TAL-CO SUPPLEMENTAL INSTRUCTION #05-R1			
Project Name:	RW TOMLINSON - NEW HEAD OFFICE		
Project Location:	100 Nortel Drive, Ottawa, Ontario		
ARCH. SI #:	A-111, 112, 115	Issued By:	Chris Simpson
STRUC. SI #:	SSI #5	Date Issued:	September 23, 2016
MECH. SI #:	N/A	Revision #:	1
ELEC. SI #:	N/A	Revision Date:	September 26, 2016

Title: Slab Edge Revisions

STRUCTURAL SITE INSTRUCTION No.: 005

1 GROUND FLOOR SLAB EDGE PLAN
A111 SCALE #1/8"

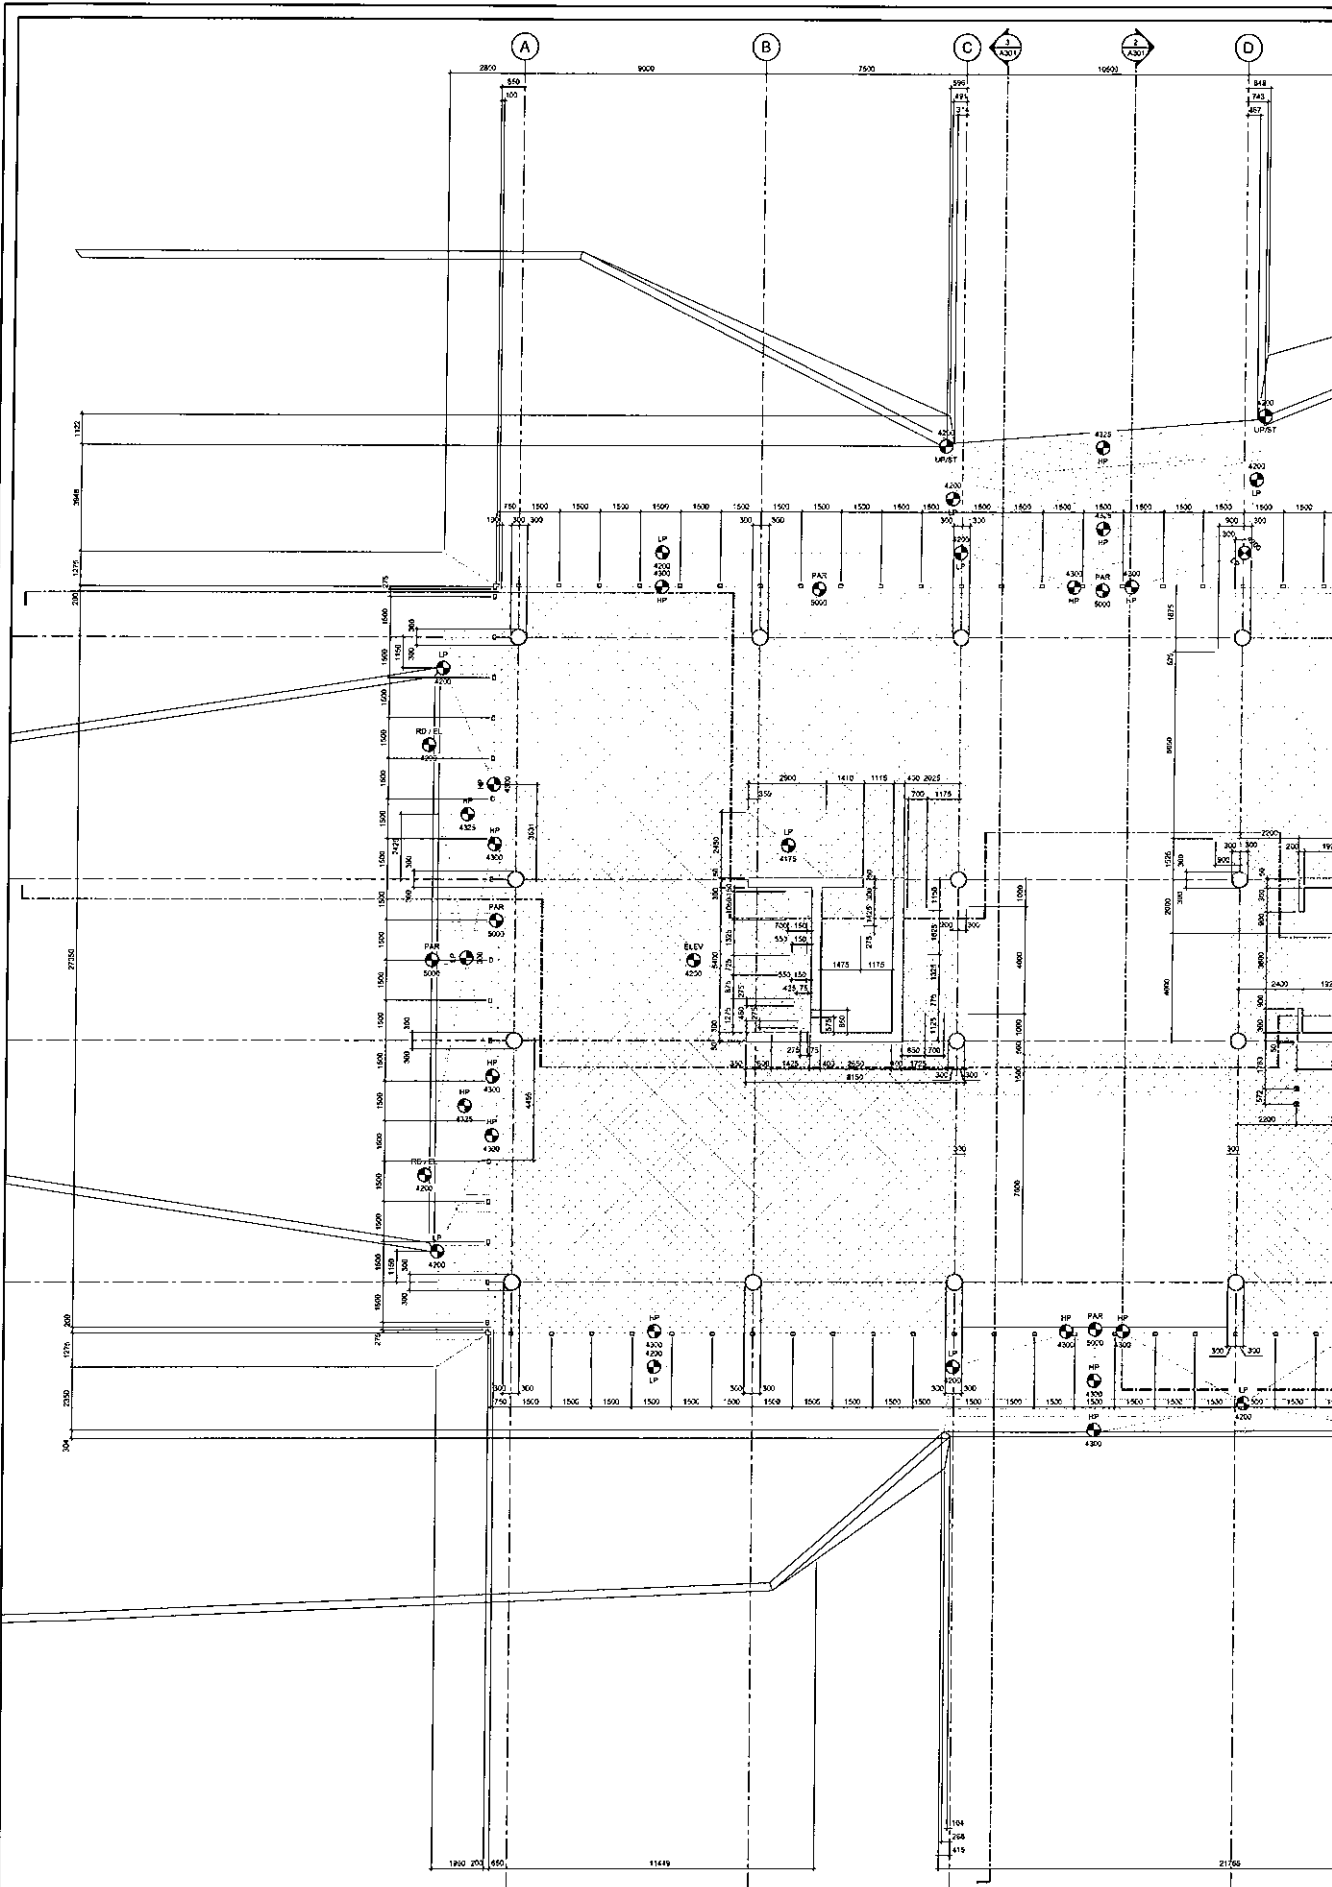
Reason: Slab depressions to accommodate floor finishes, modification to mechanical chases.

1 SECOND FLOOR SLAB EDGE PLAN
SCALE = 1/100

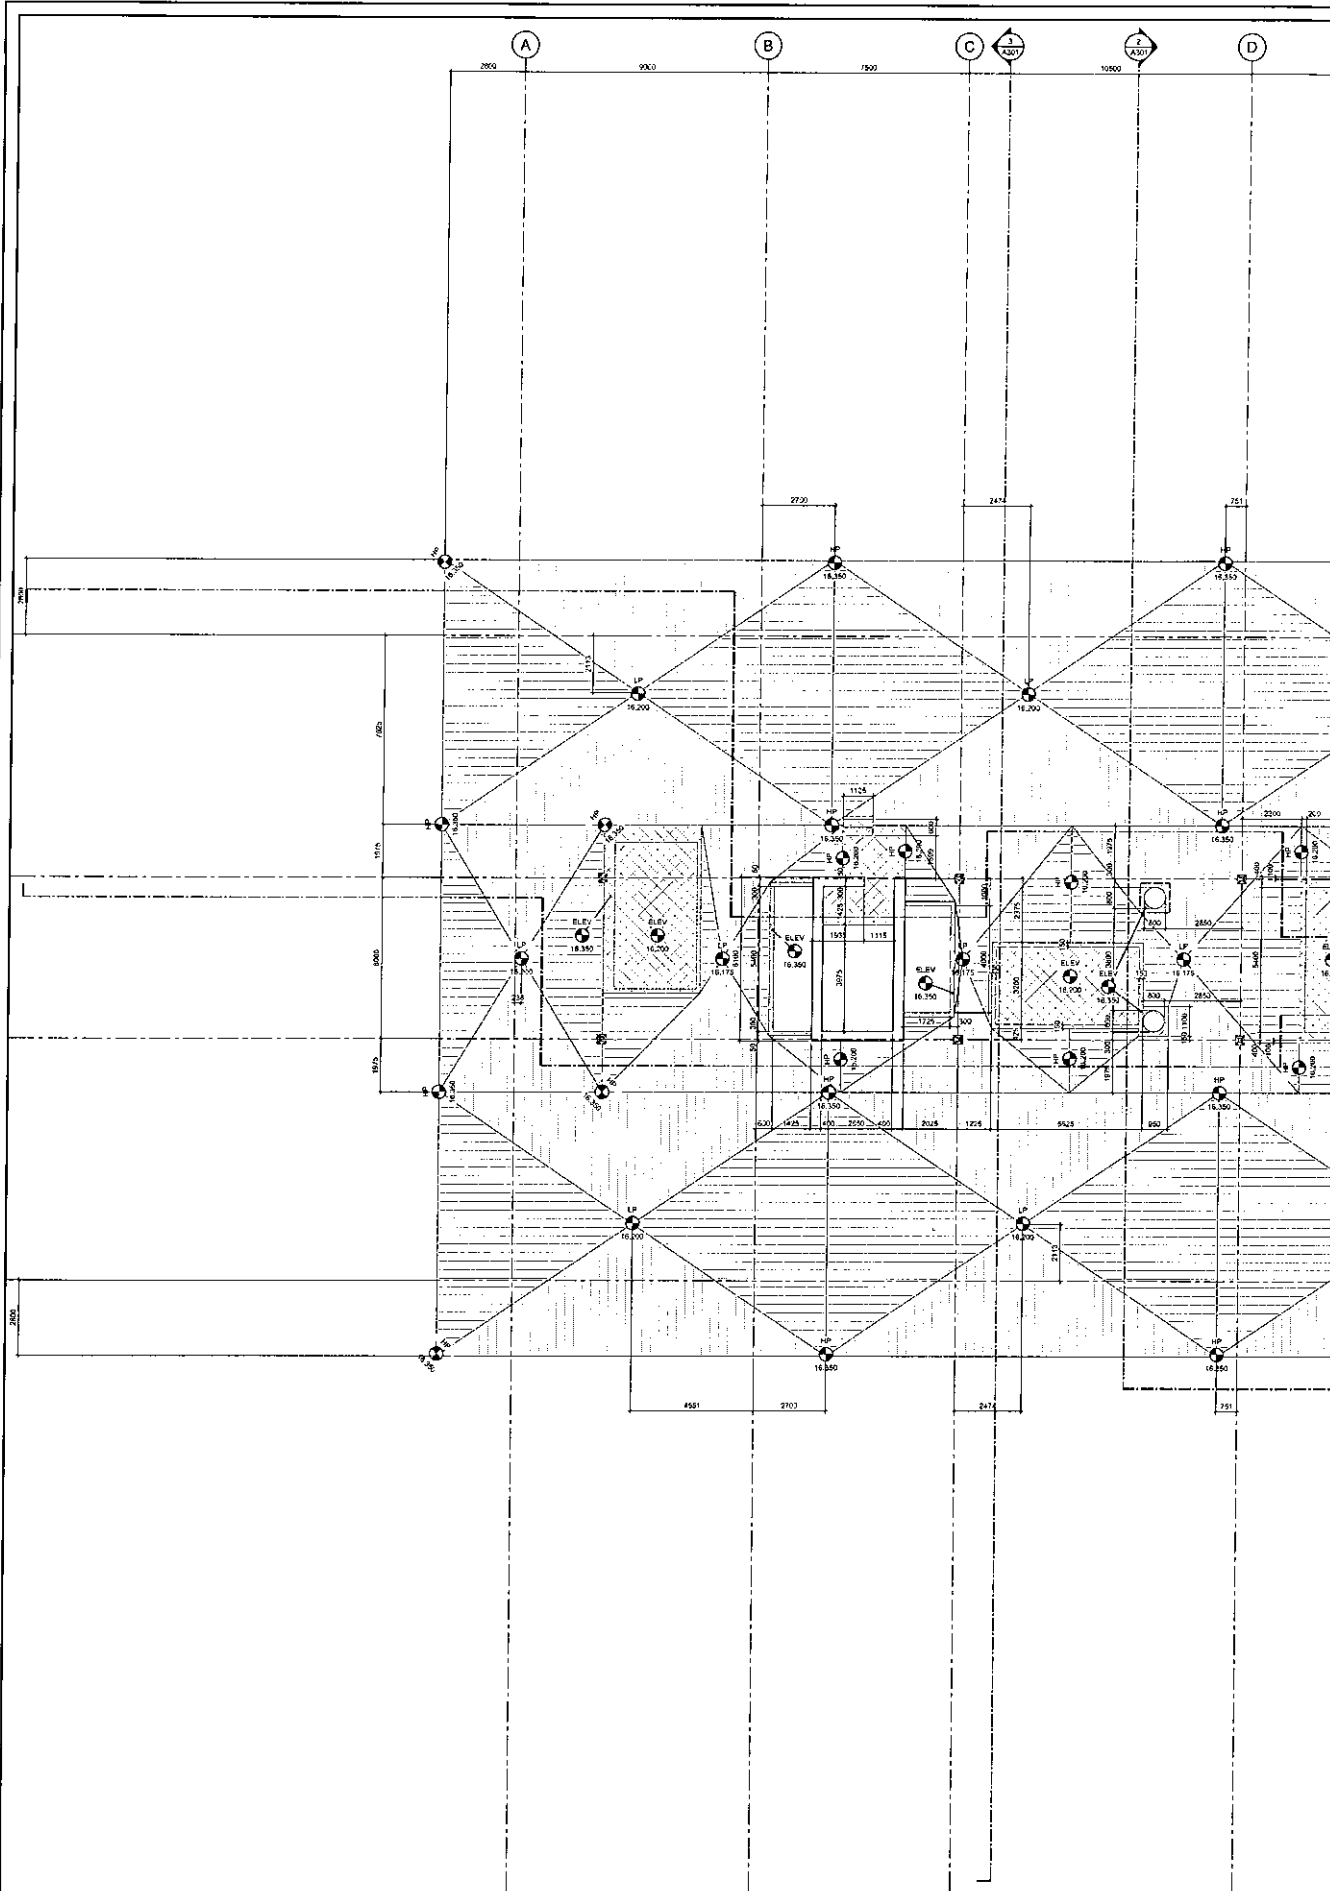
The Slab Edge between GL (2&3) now extends to 200mm North of GL (C), not 300mm as indicated on the Revised Building Permit submission and SI #05. For clarification, please see attached for updated A112.
 Slab edge revisions relating to formwork and reinforcing steel.

**SSI-S5
SK1**

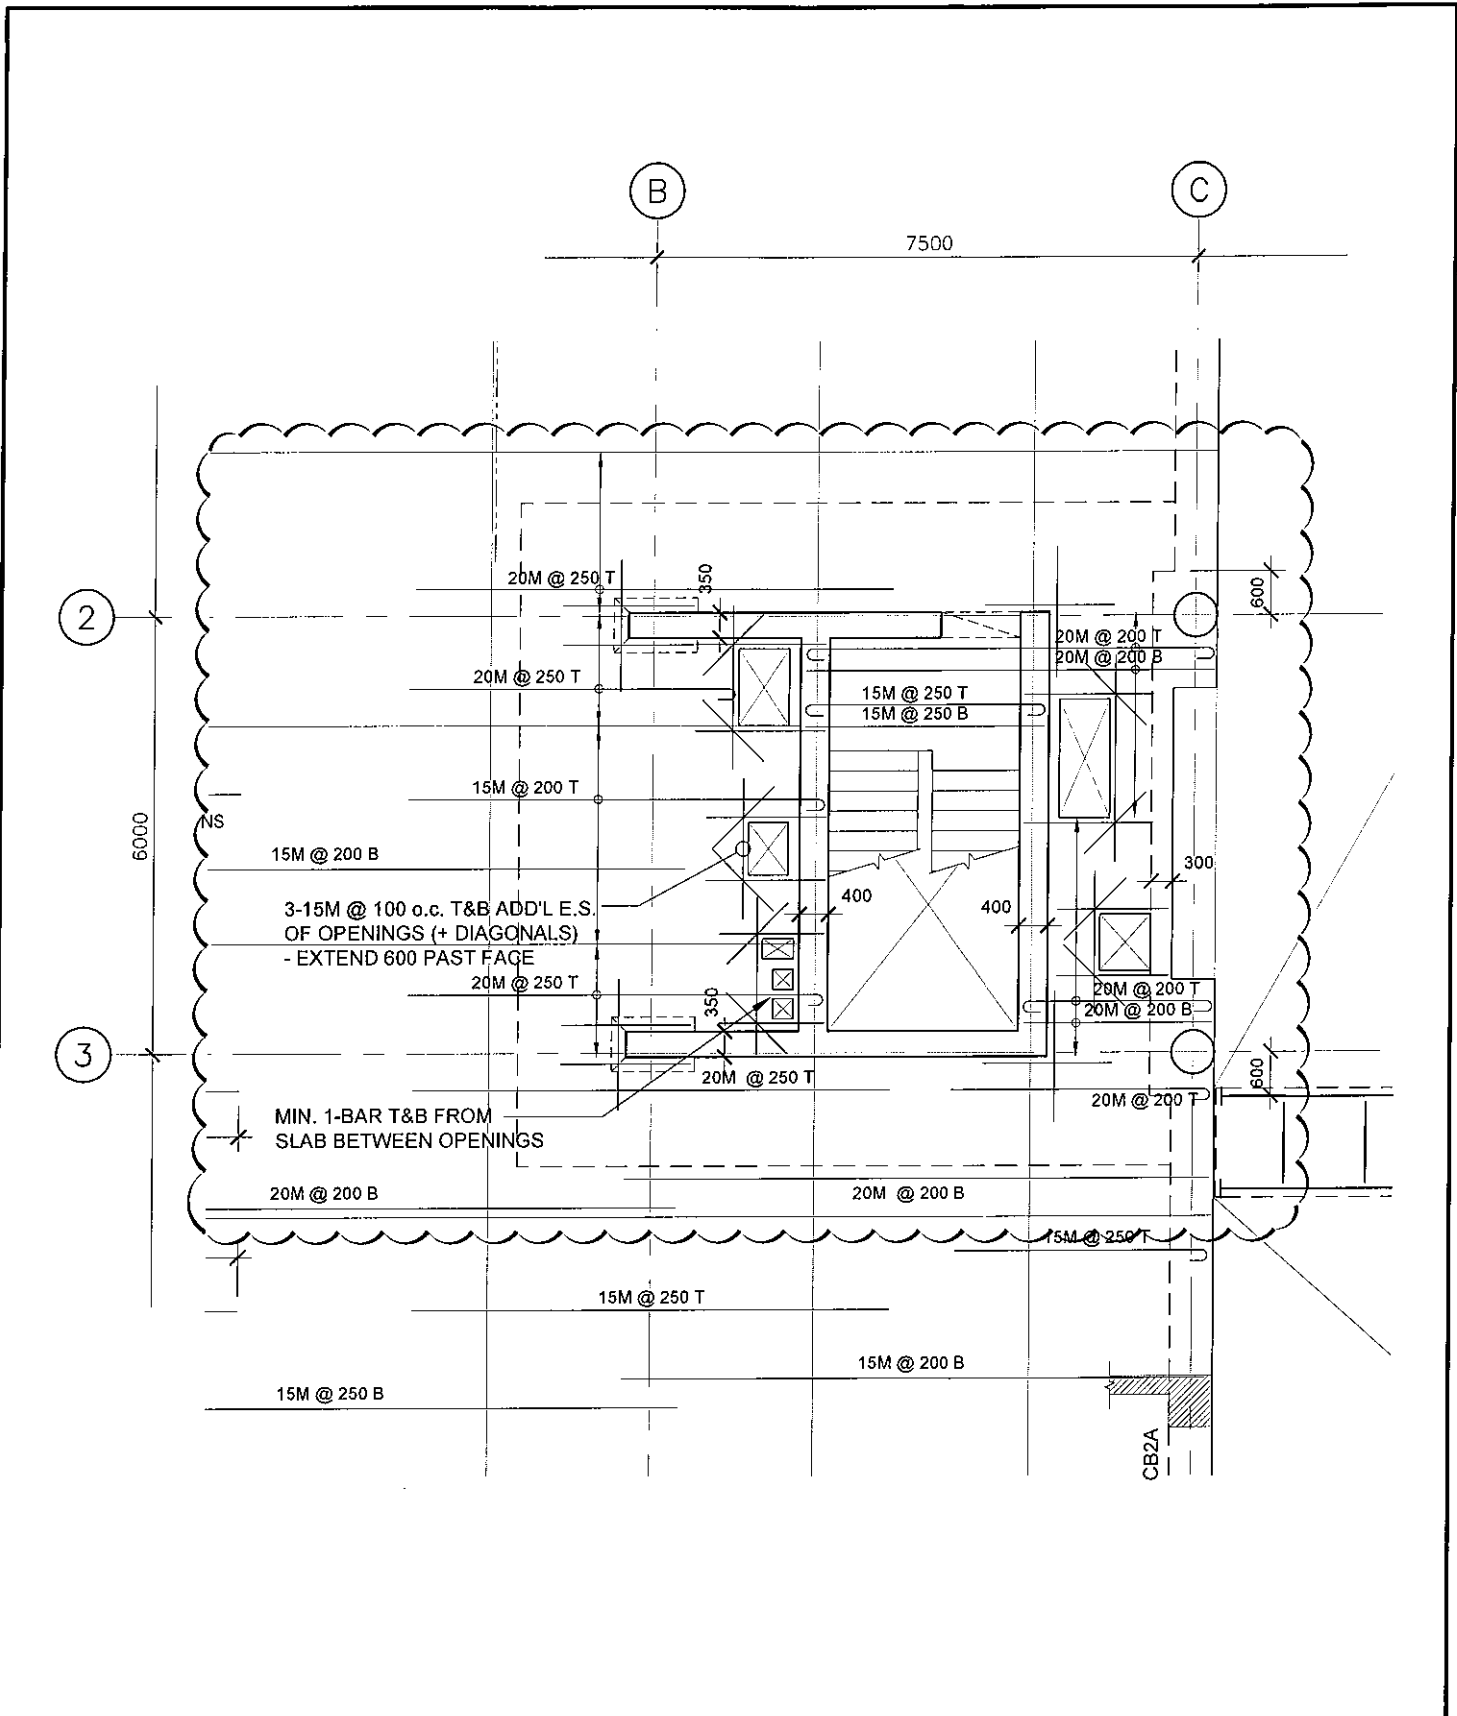
Revised the concrete and steel reinforcing at the 2nd floor to suit the revisions noted in the attached sketches SK1 to SK5.
